B-052 April 15, 2003

SAFETY RECALL CODE 0826 - SIDESTAND LEG FOR 2003 LIGHTNING XB9SL

Figure 1. Sidestand Assembly with Sidestand Leg (Part No. 94218Y)

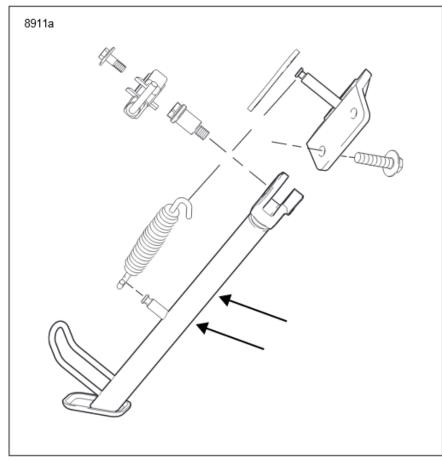
As recently advised, Buell Motorcycle Company has decided that there is a safety defect with the sidestand legs on certain 2003 XB9SL motorcycles which causes them to have the potential to bend or break without notice, thereby allowing the motorcycle to fall and potentially cause an injury.

See Figure 1. The correct replacement sidestand for the purpose of this bulletin is Part No. 94218Y.

Figure 2. Sidestand Assembly

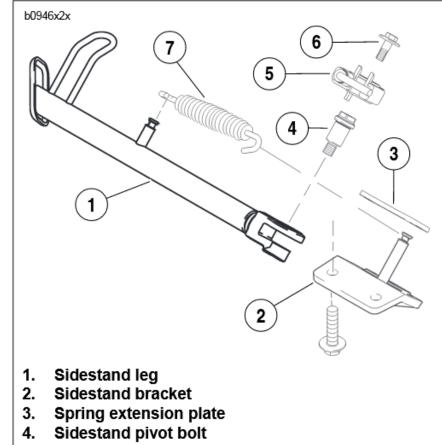
- 2. See Figure 2. Remove sidestand switch (5).
 - Retract sidestand leg (1).
 - b. Remove switch fastener (6).
 - c. Extend sidestand leg.
 - d. Lift sidestand switch and slide to the right away from spring post on sidestand bracket (2) and leave attached to harness.
- 3. Remove sidestand leg (1).
 - Retract sidestand leg.
 - Remove sidestand spring (7) and spring extension plate (3) using SNAP-ON SPRING TOOL (Part No. HE-52B).
 - c. Remove sidestand pivot bolt (4).
 - d. Extend sidestand leg and remove.

- c. See Figure 2. Install sidestand leg (1) and sidestand pivot bolt (4) tightening to 18-20 ft-lbs (24-27 Nm).
- Retract sidestand leg.
- Install spring extension plate (3) and sidestand spring (7) using SNAP-ON SPRING TOOL (Part No. HE-52B).

Figure 3. Lubricating Points (Shaded Areas)

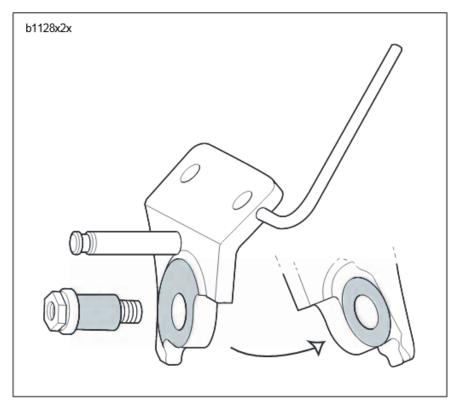
- 1. Install sidestand leg (1).
 - See Figure 3. Lubricate sidestand pivot bolt and mating portions on sidestand bracket with WHEEL BEARING GREASE (Part No. 99855-89).
 - b. See Figure 4. Apply LOCTITE 272 (Red) to threaded area (clevis) of sidestand leg.

Figure 4. Threaded Area for Loctite Application

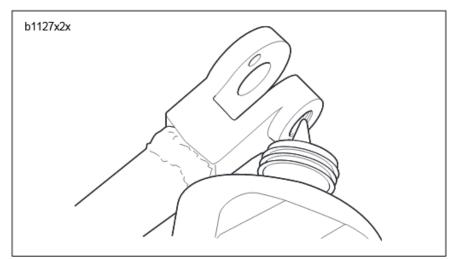
Applying LOCTITE to threaded area of clevis on sidestand leg, instead of threads on the pivot bolt, will eliminate build-up between clevis and sidestand bracket which can interfere with the applied lubricant.
